ZAYO'S PRINEVILLE TO RENO PROJECT

CPUC MINOR PROJECT REFINEMENT FORM

Date Requested: 15 Oct 2024 submitted to CPUC on October 21, 2024	Report No.: 6
Date Approved: 10/25/2024	Approval Agency: Caltrans, in addition to CPUC
Property Owner(s): Caltrans (State Route 395 ROW)	Location/Milepost: PM M-26.1 to M- 26.7(S to N)
Land Use/Vegetative Cover: Ruderal (maintained highway shoulder near edge of pavement)	Sensitive Resources: Waterways are present (adjacent to North Fork Pit River). No other sensitive resources present. (See project webmap.)

SHEET NO.: 82 OF 94

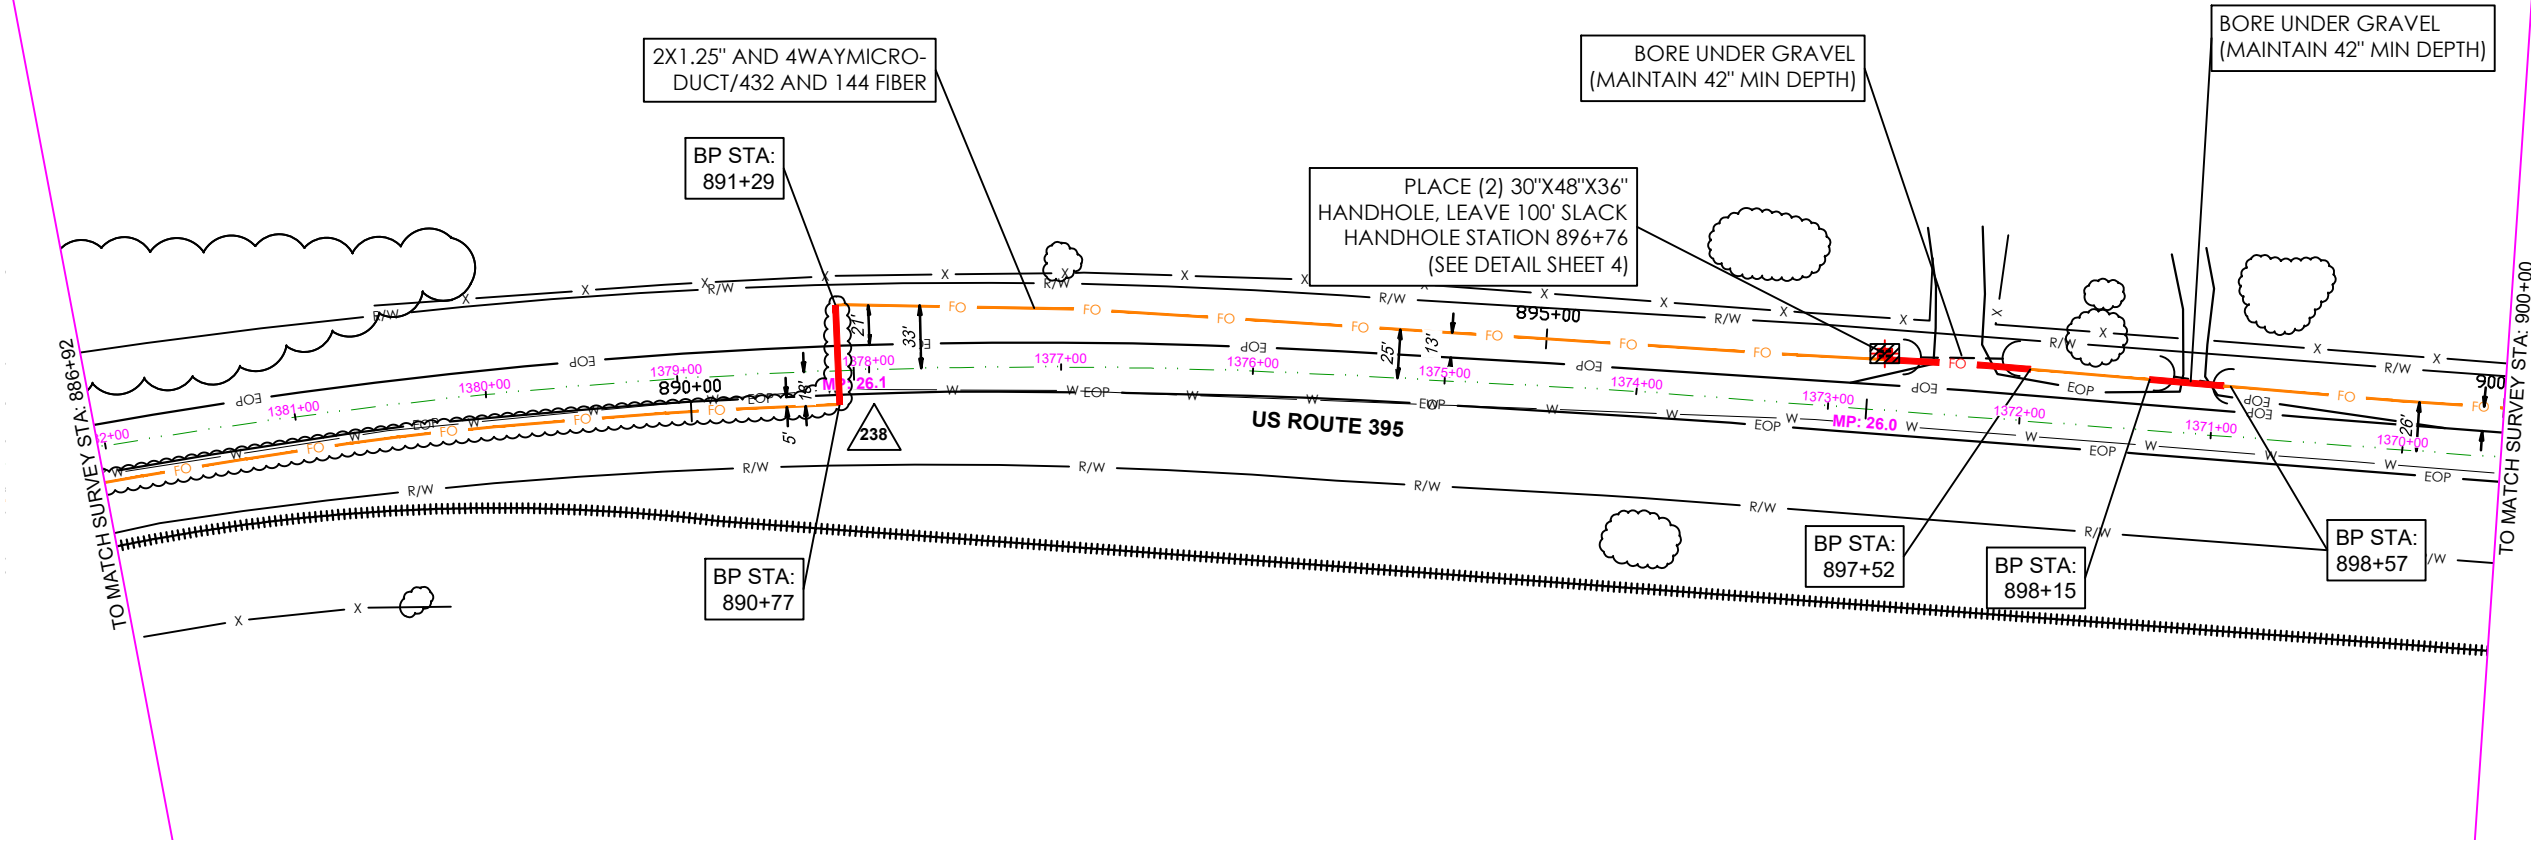
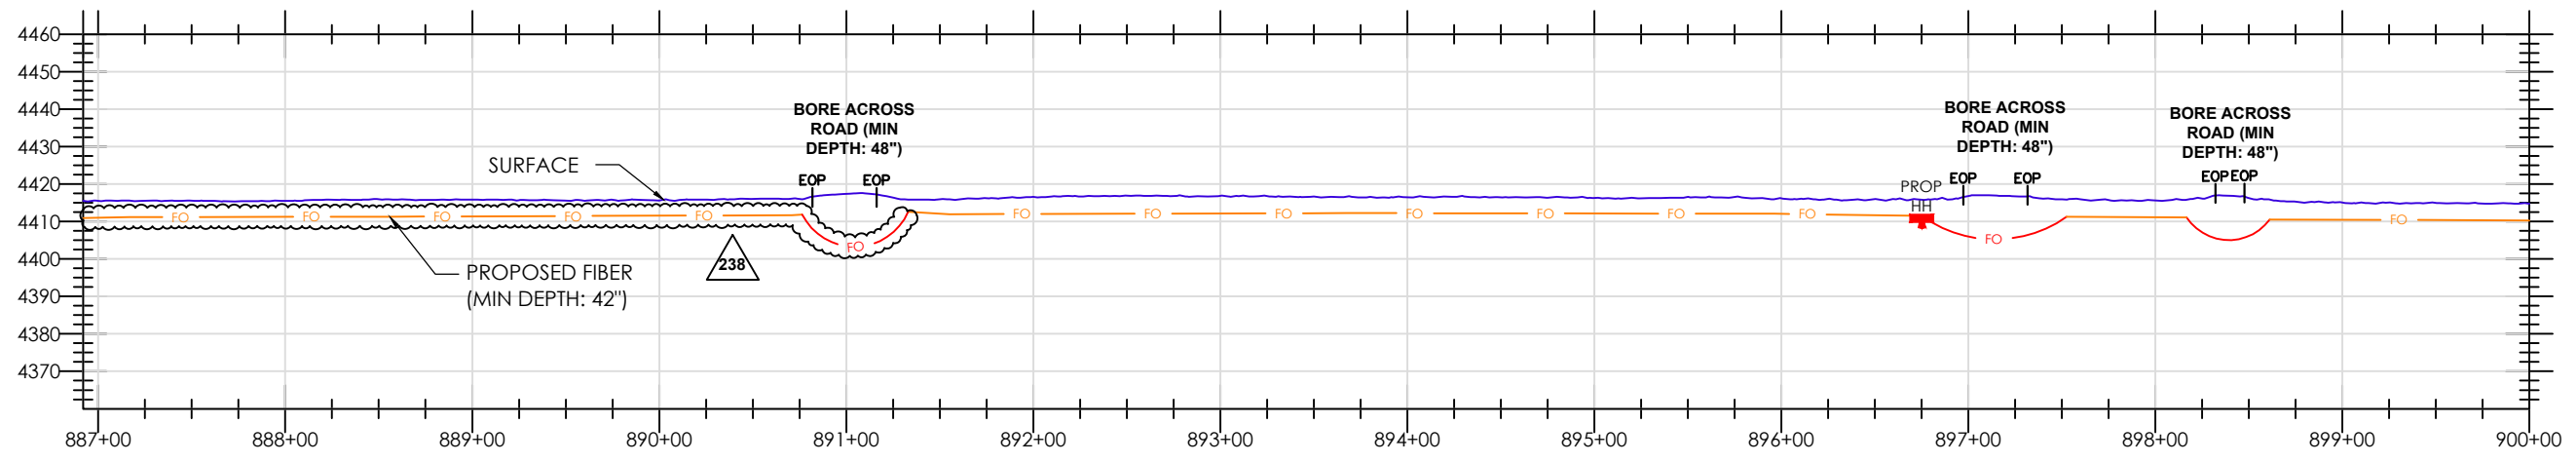
RFI NO. 0238
SHIFT ALIGNMENT 5 FEET FROM EOP ON WEST SIDE STA 882+25 TO STA 890+50
